COURT STREET SEWER SEPARATION PROJECT

Addendum No. 1

March 25, 2016

SHEET NUMBER
00 C-102

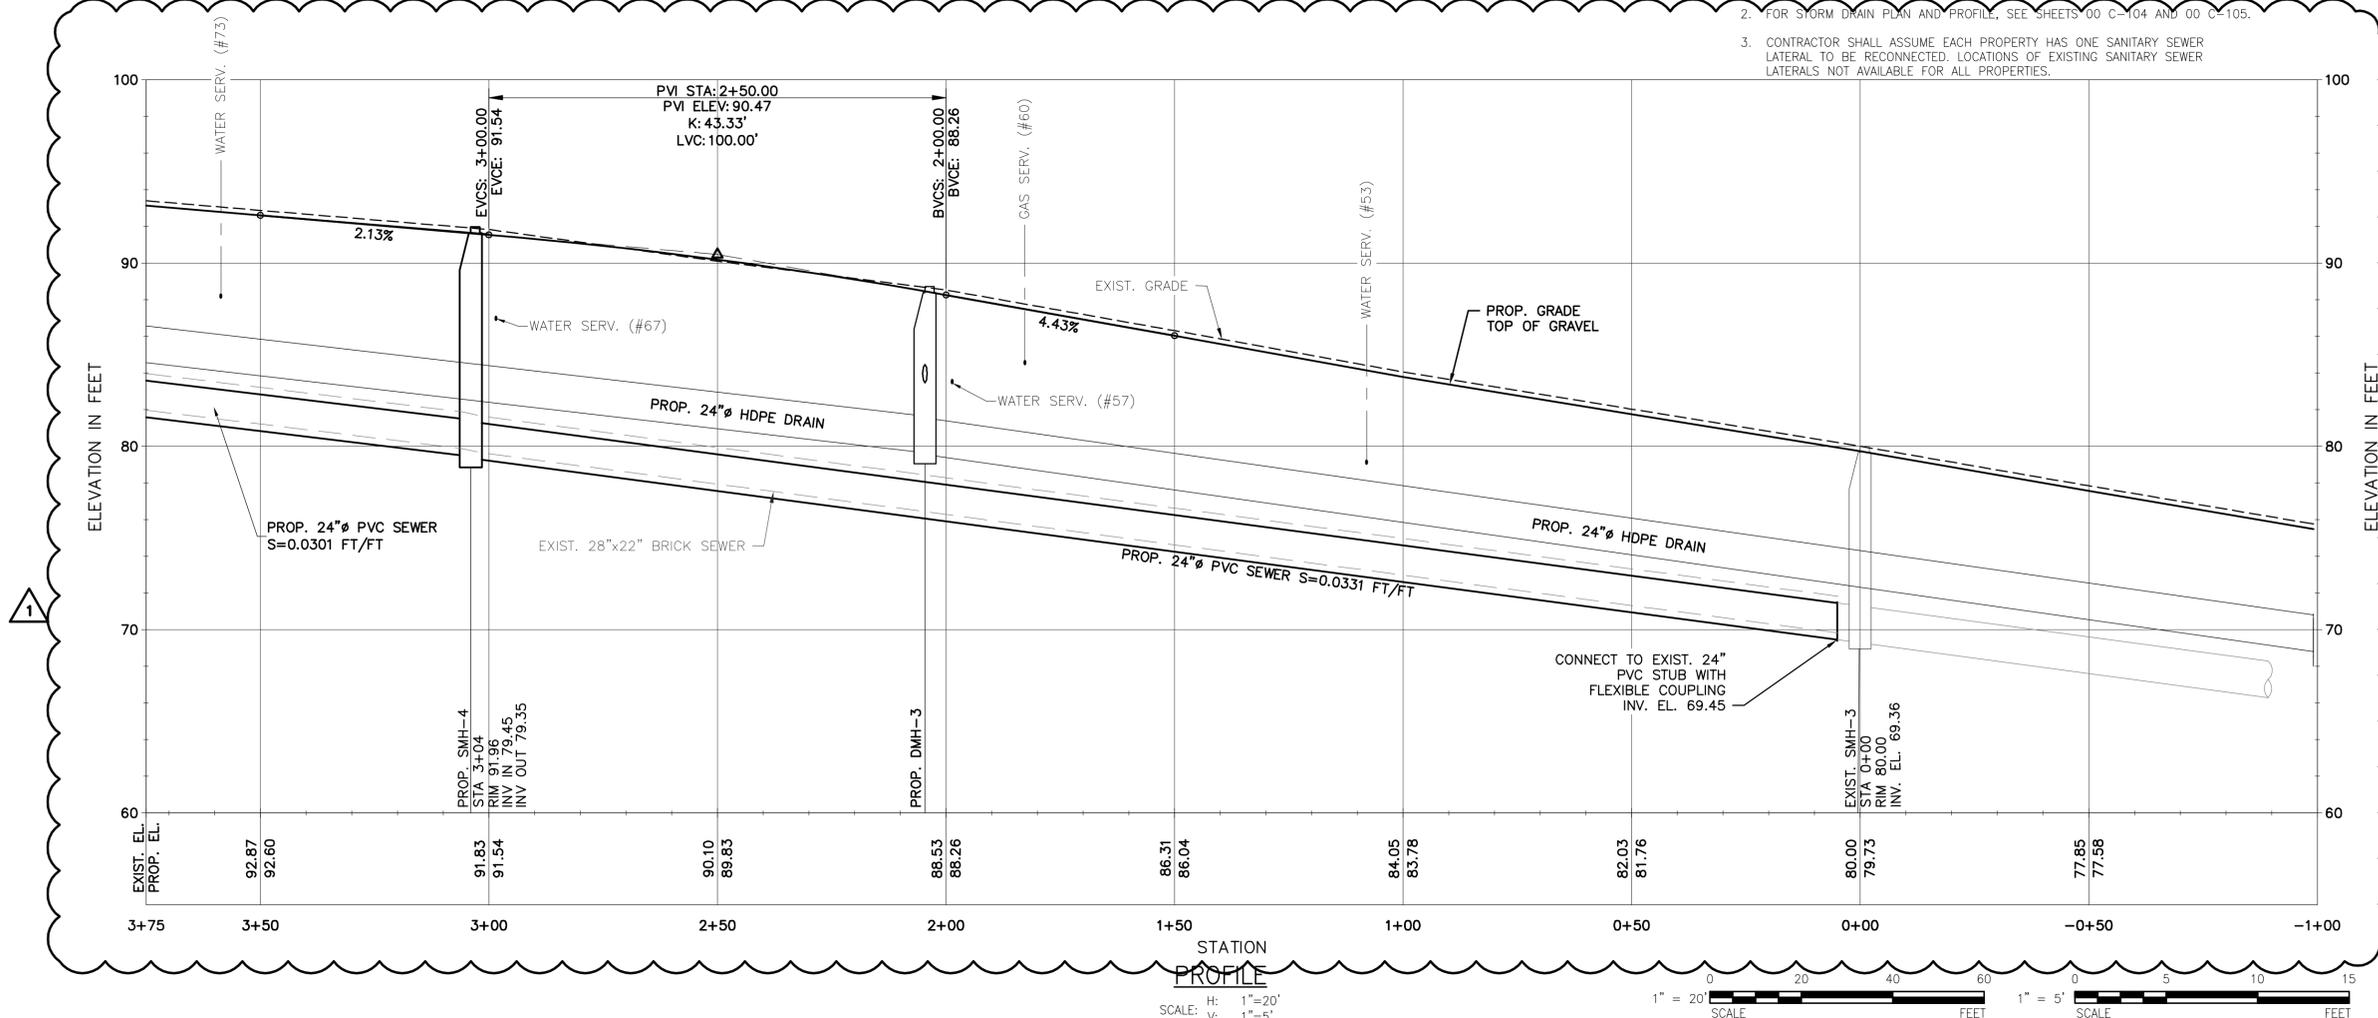
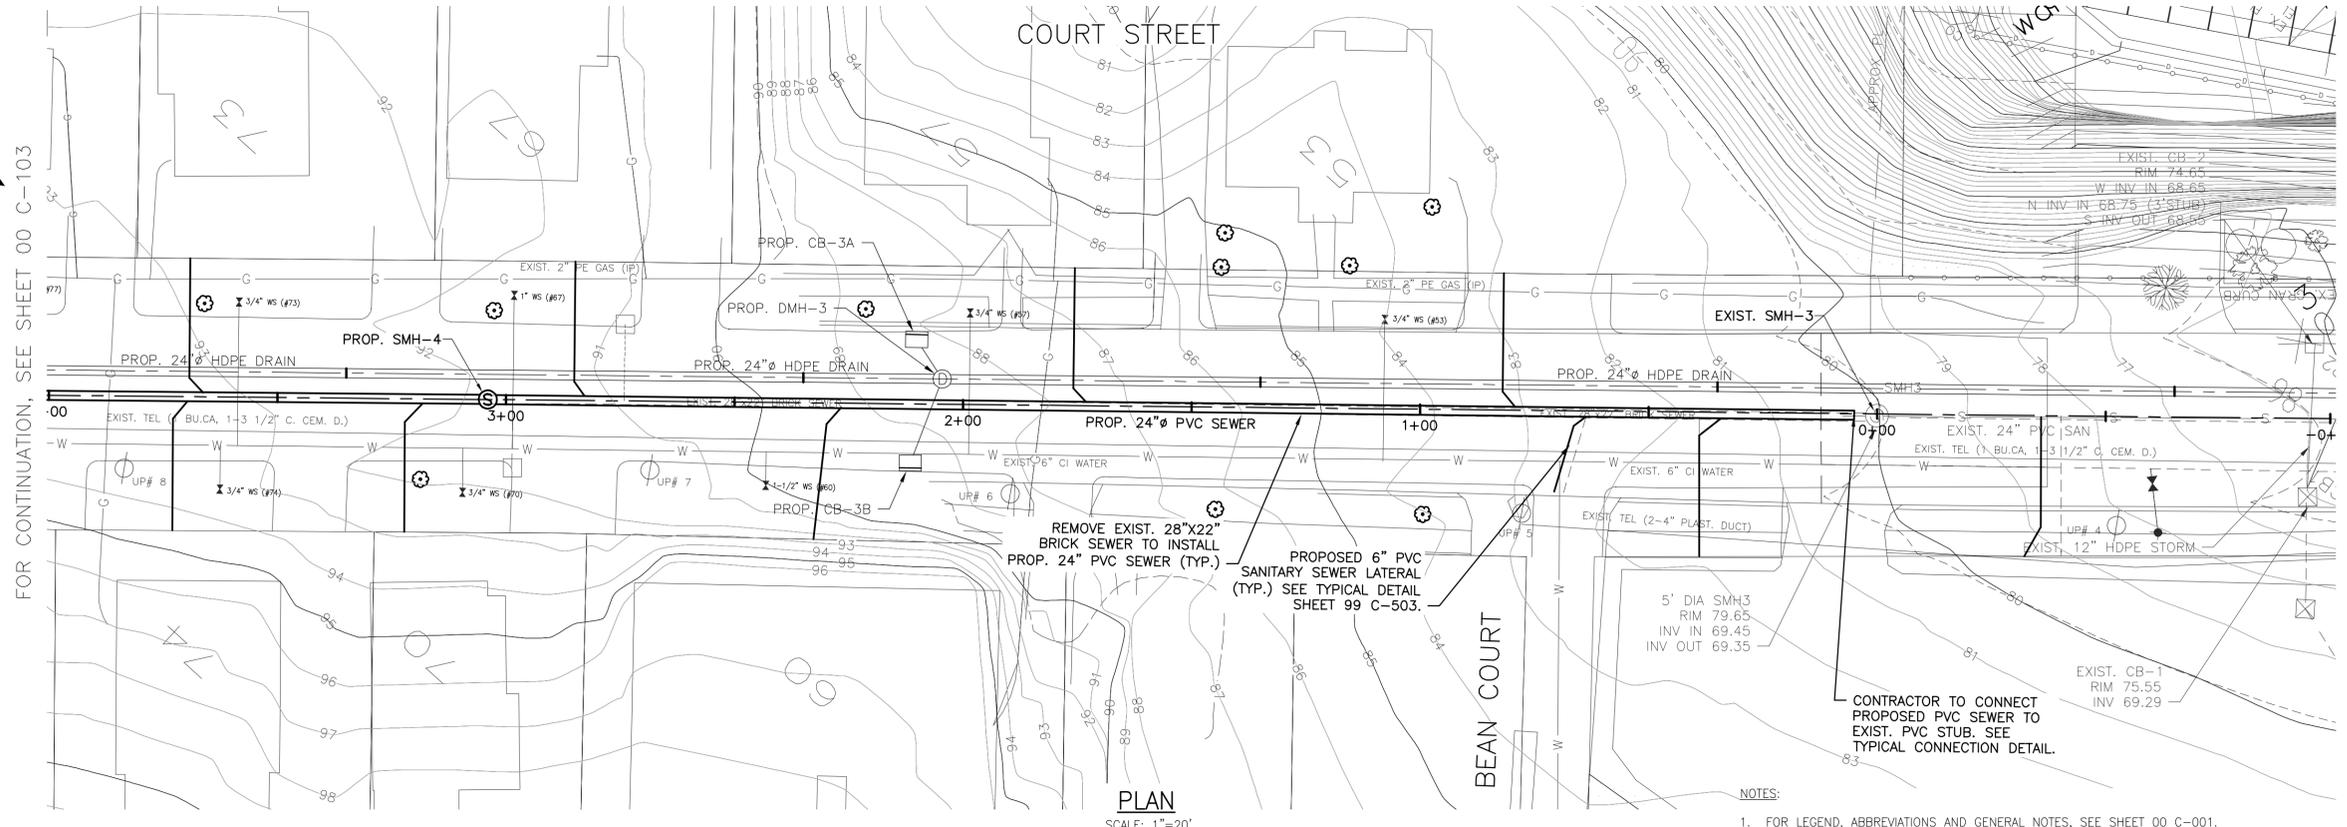
1. Replace Sheets 00 C-102 and 00 C-103 with new sheets, attached, with additional information related to proposed finish grade of gravel and vertical curves.
2. Replace Sheets 00 C-104 and 00 C-105 with new sheets, attached, with updated catch basin rim elevations.

1. Contractor requested centerline profile. Road appears to be superelevated, what is intent for grading?

I/R	DATE	DESCRIPTION
1	3/24/16	PROP. GRADE CENTERLINE

See attached plan sheets for centerline gravel grade finish elevation. The City reviewed survey data and while there is not currently a well established crown or a consistent cross slope at all points along Court Street, the road is not superelevated. Some cross slope does exist from centerline to each edge of pavement along the majority of the project area. The section included in the details is a typical section, considerations will have to be made for existing driveway and sidewalk grades that need to be matched into but where possible the road should be graded to establish crown and cross slope.

PATH: \\BANGOR\IT\2016\CAD\PROJECTS\2016\COURT ST\1600_CAD\SHEETS\00 C-103.DWG
 LAST UPDATE: Thursday, March 24, 2016 10:40:32 AM
 PLOT DATE: Thursday, March 24, 2016 10:58:34 AM

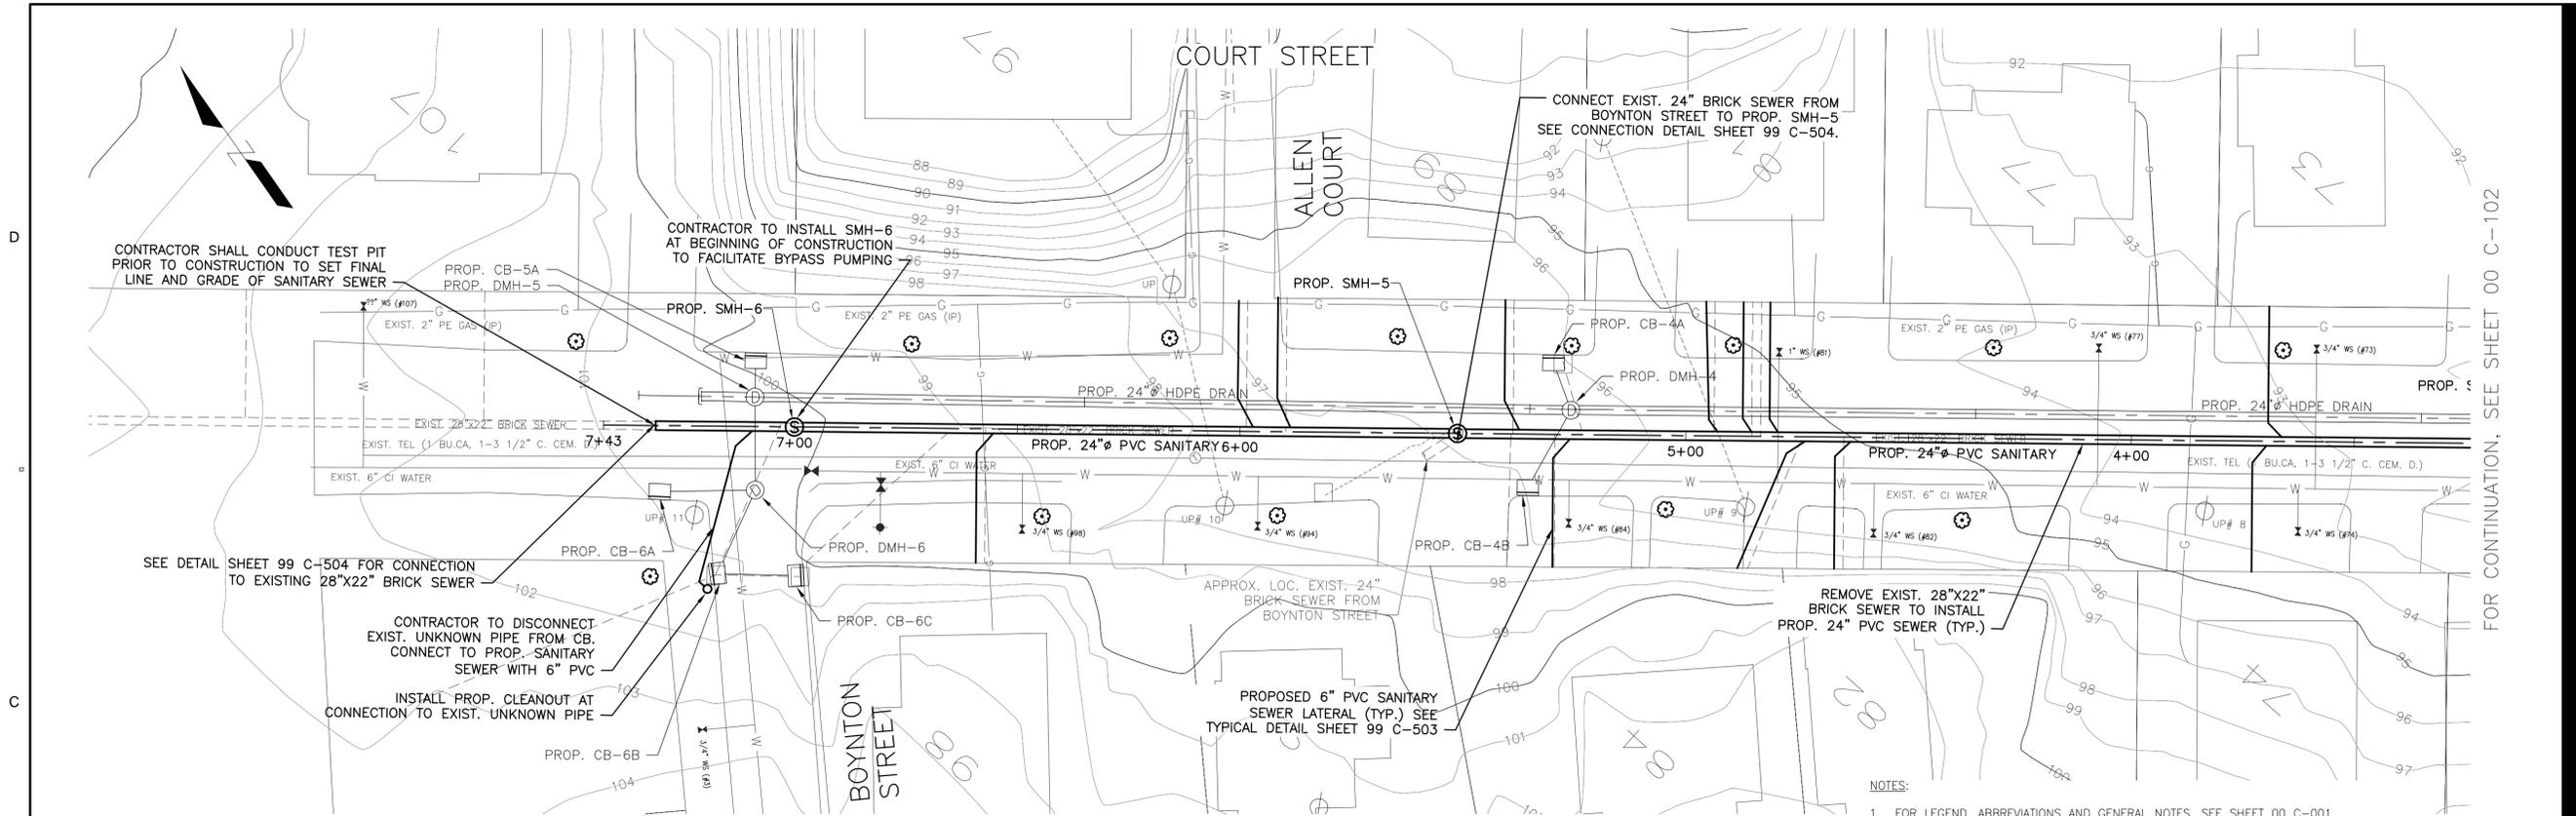
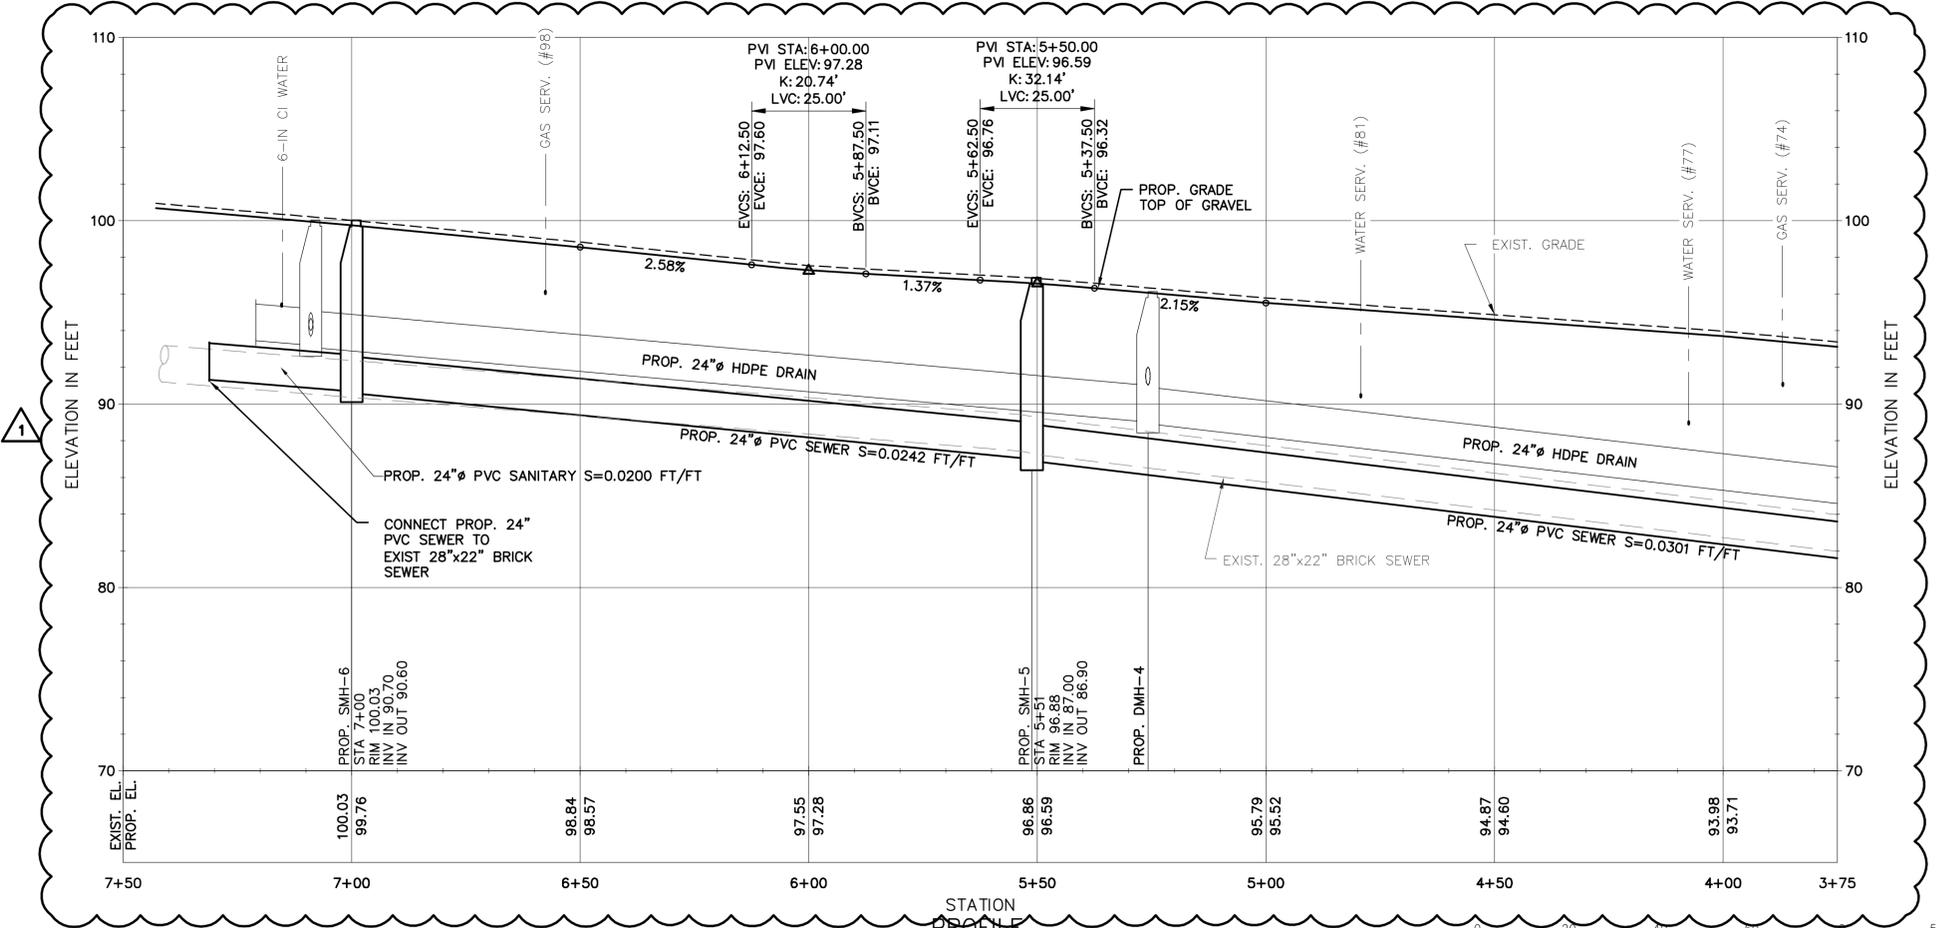
I/R	DATE	DESCRIPTION
1	3/24/16	PROP. GRADE CENTERLINE
